M E M O R A N D U M

SUBJECT: **SP24-012: Parker Central Area F5 L2 B1 - McDonalds– Site Plan Amendment**
Review Comments 03

SITE DEVELOPMENT PLAN
MCDONALDS REMODEL AT PARKER CENTRAL AREA
FILING NO. 5, BLOCK 1, LOT 2

SHEET NO: C1.0

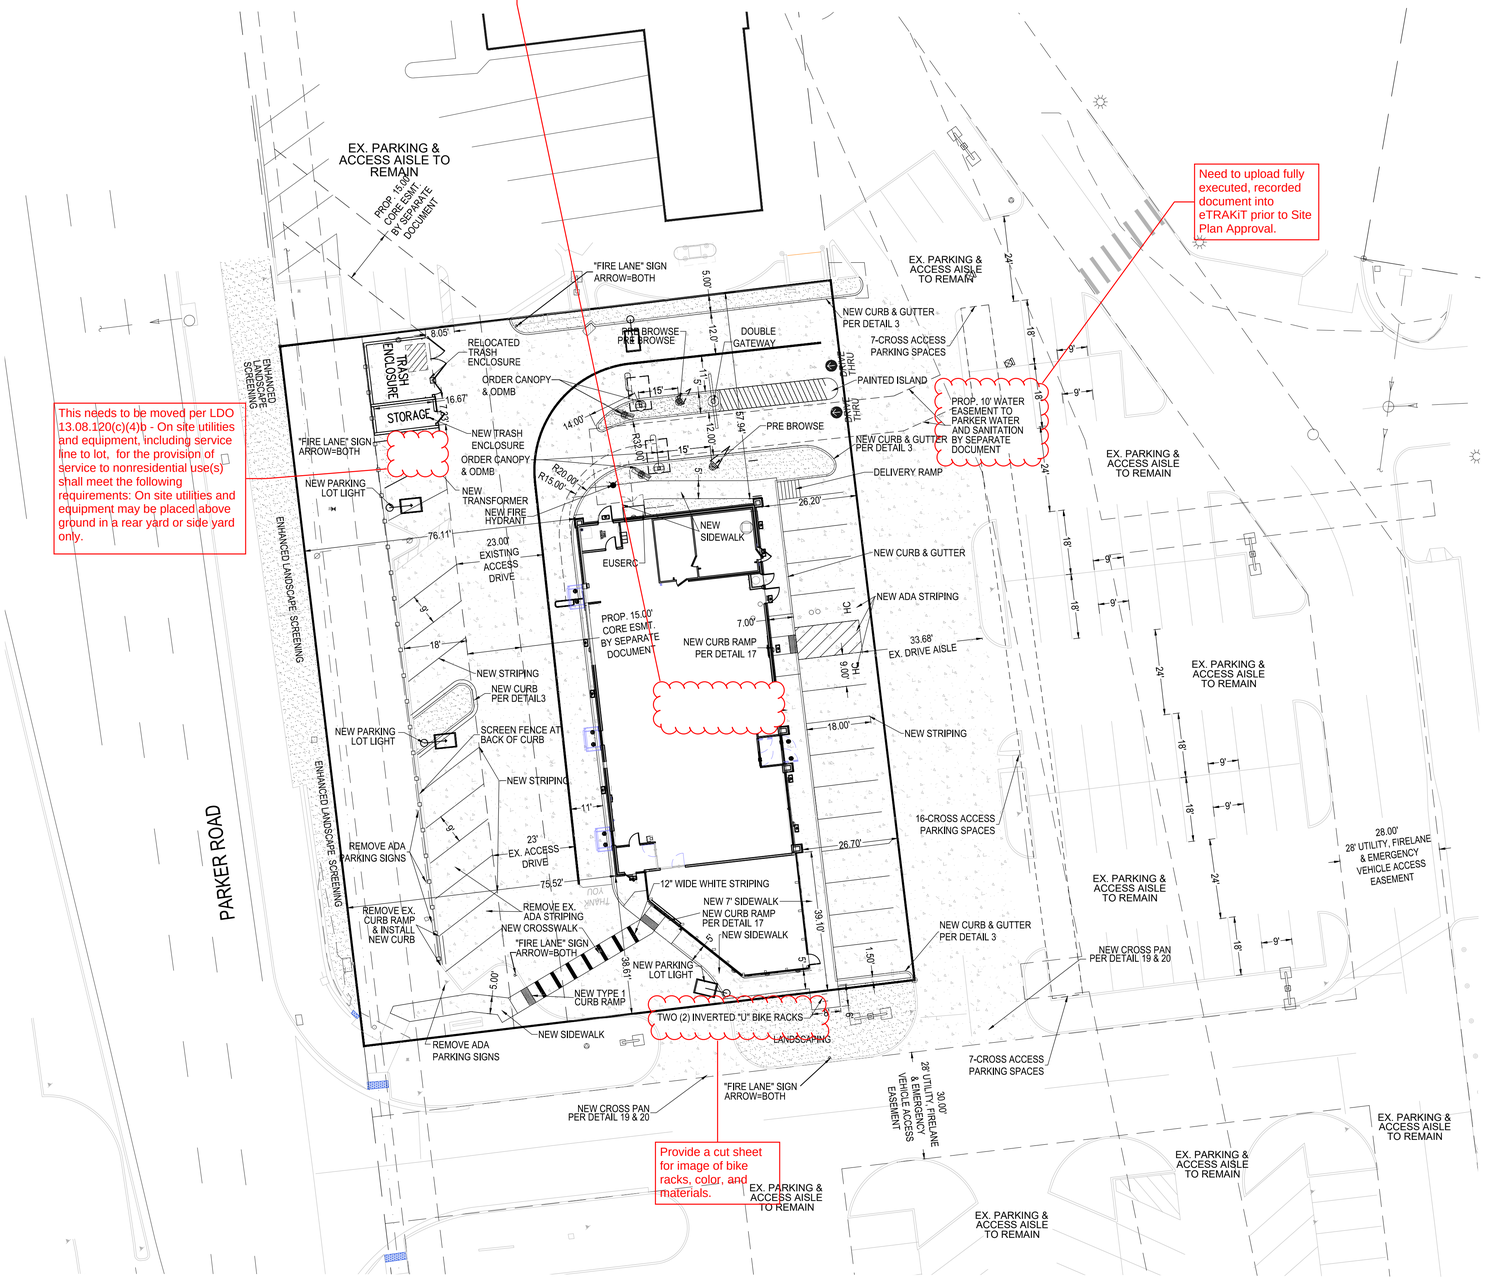
Need to upload fully executed, recorded document into eTRAKiT prior to Site Plan Approval.

This needs to be moved per LDO 13.08.120(c)(4)b - On site utilities and equipment, including service line to lot, for the provision of service to nonresidential use(s) shall meet the following requirements: On site utilities and equipment may be placed above ground in a rear yard or side yard only.

Provide a cut sheet for image of bike racks, color, and materials.

SHEET NO:
LI1.0

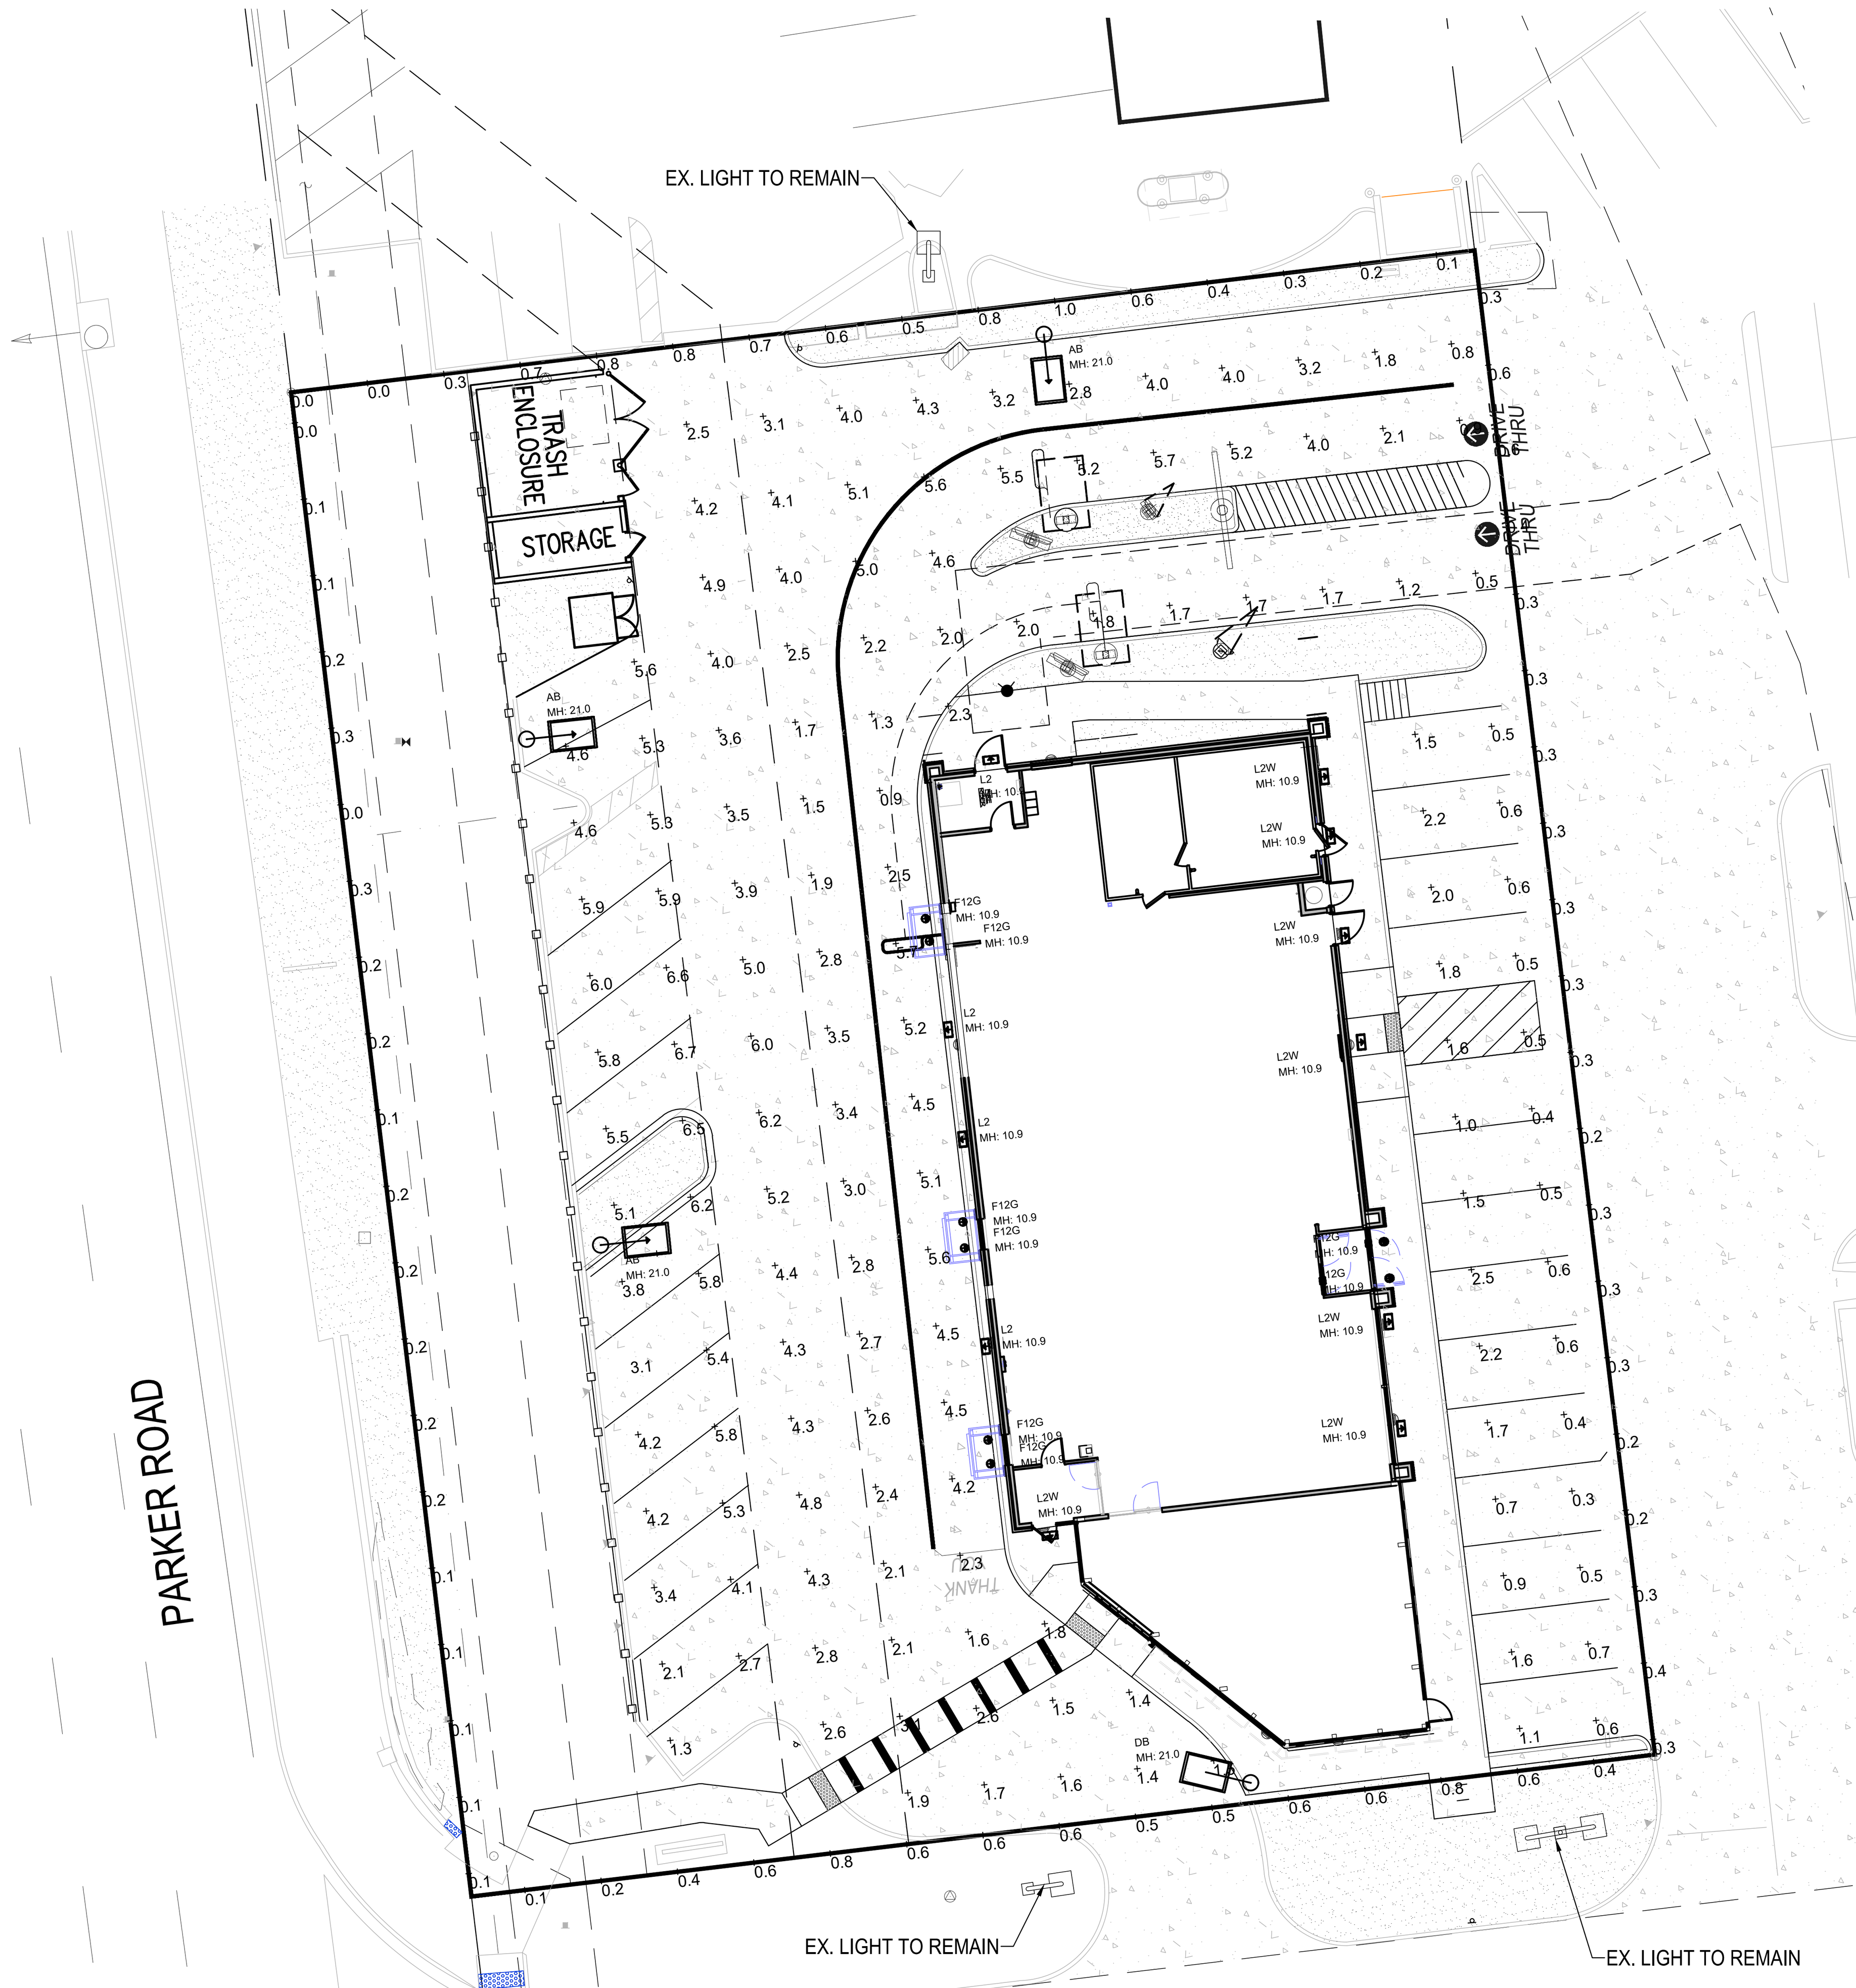
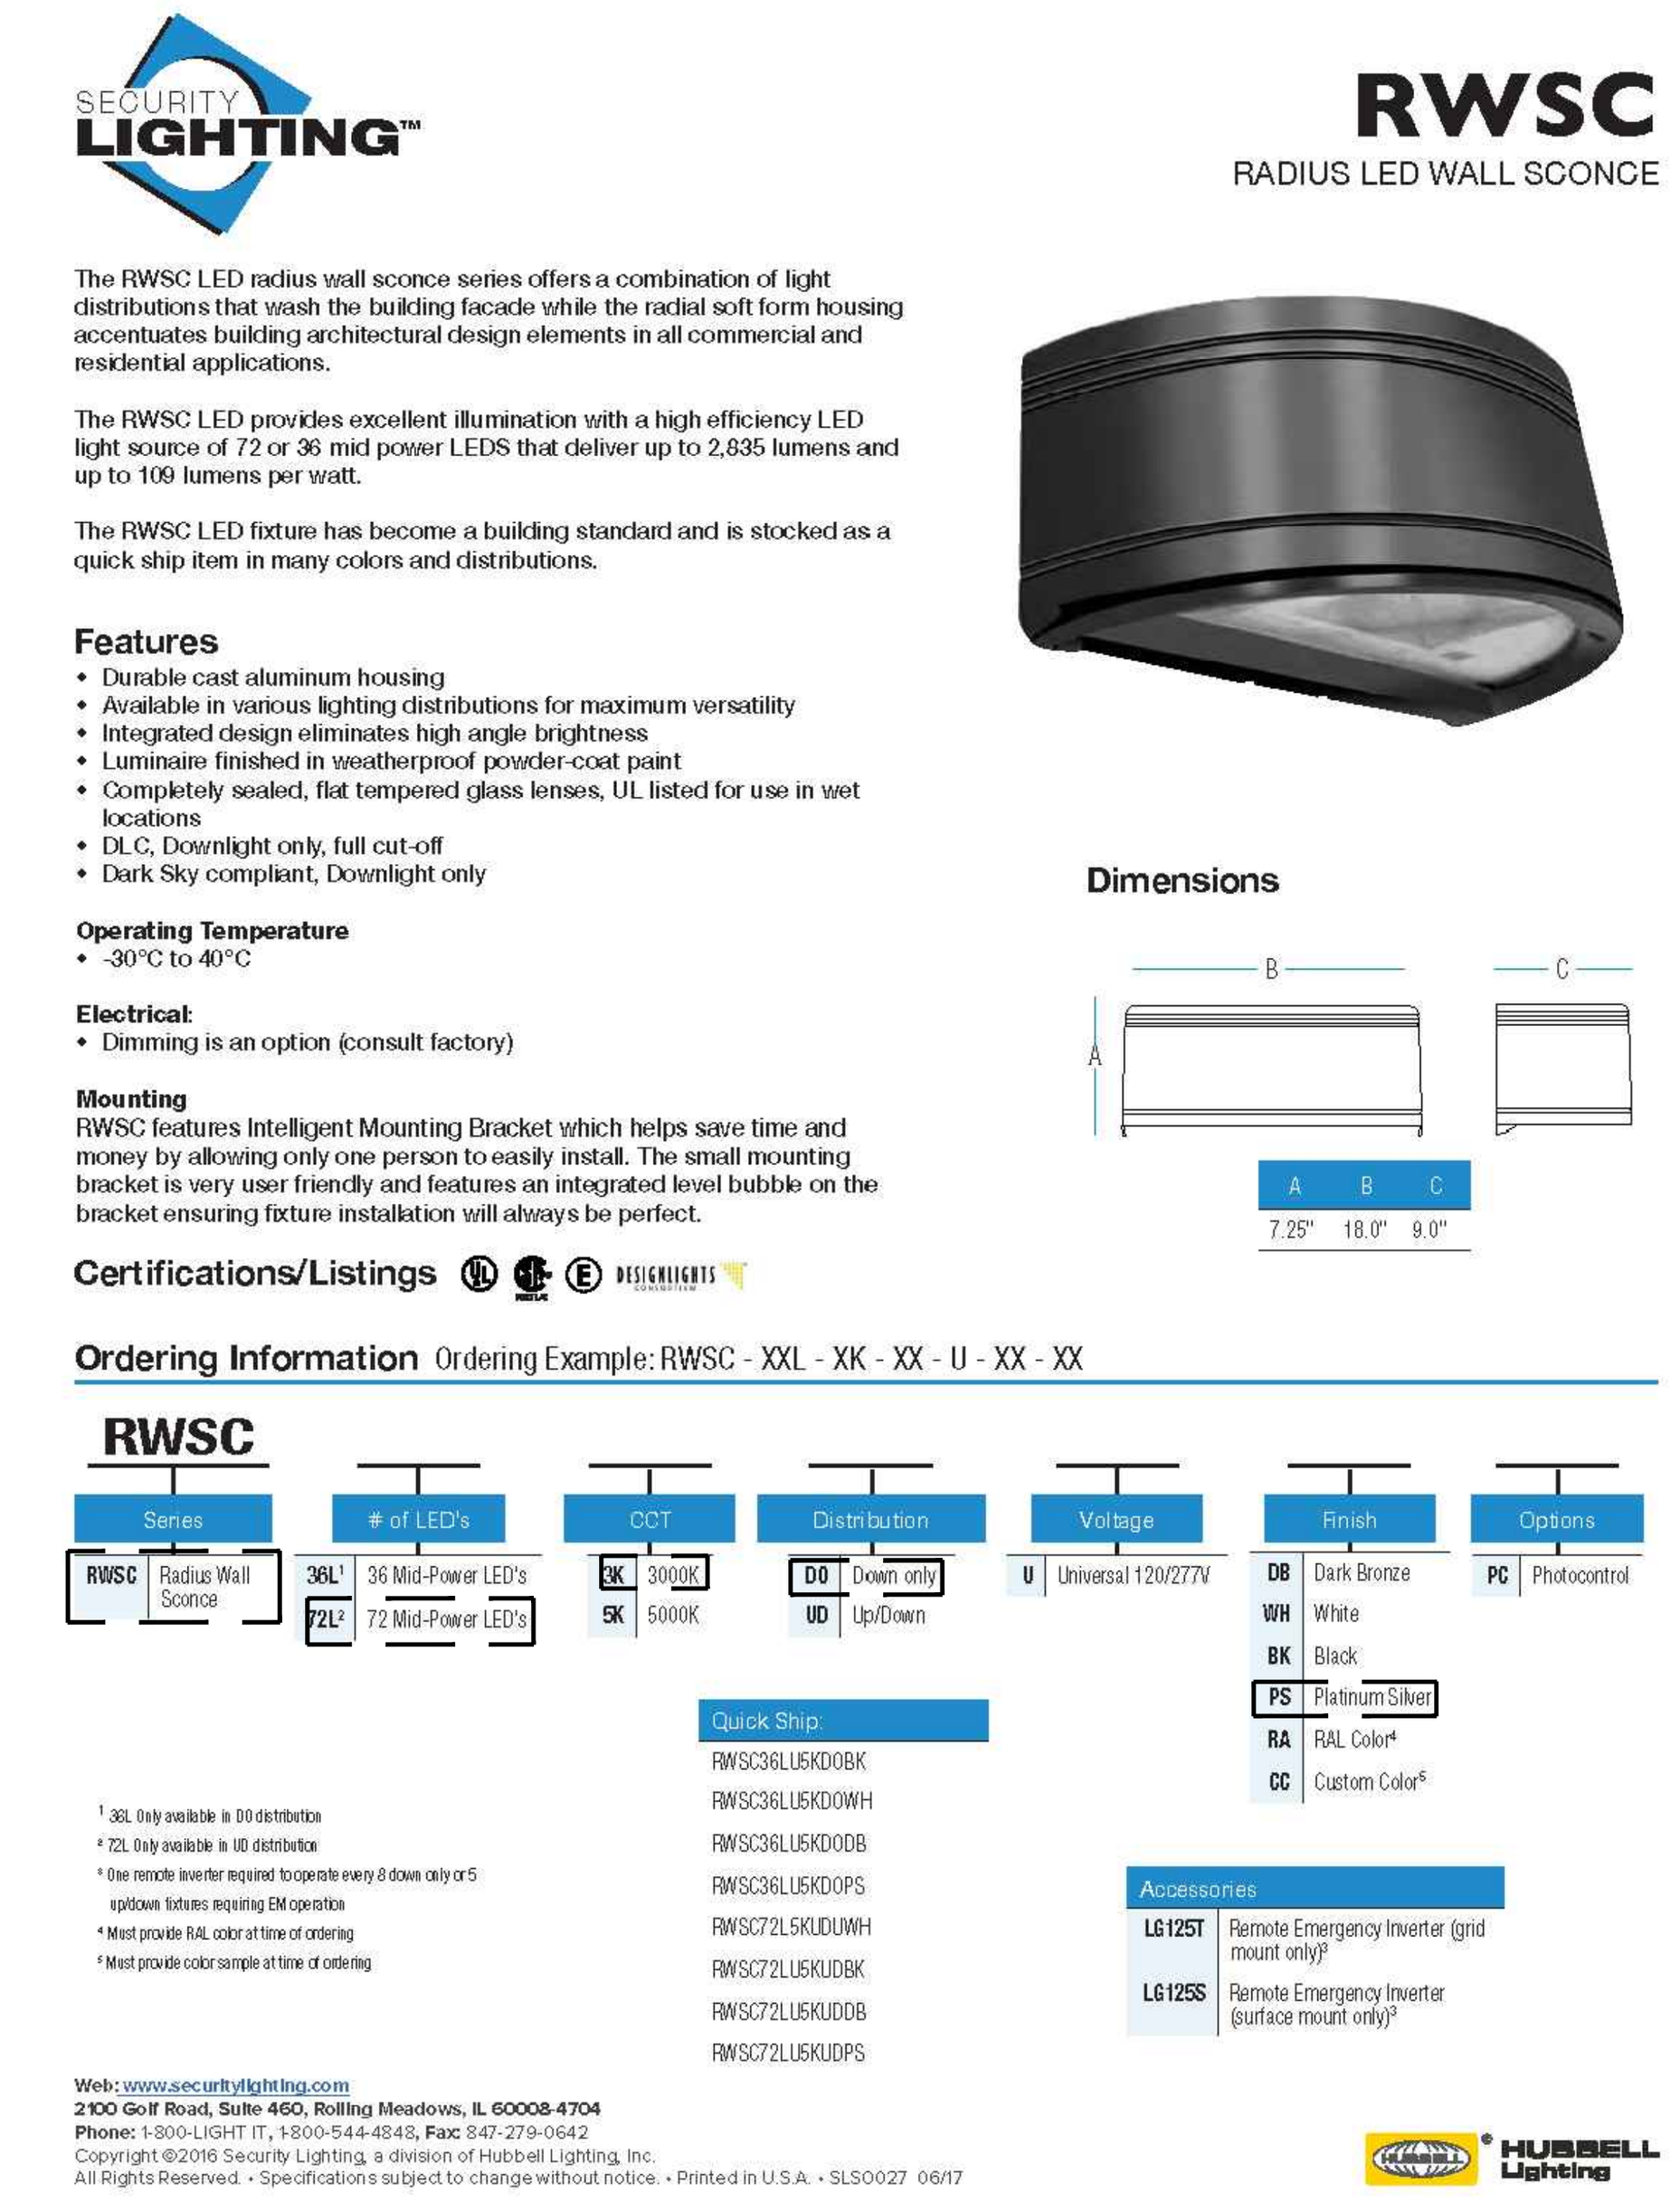
Update table. Per LDO Administrative Manual Section B.2.(f). Photometric Plan needs to include a table with the following information: light fixture,name, label, height, fixture color, total lumens, lighting type - CCT. CCT shall be below 5001 Kelvin.
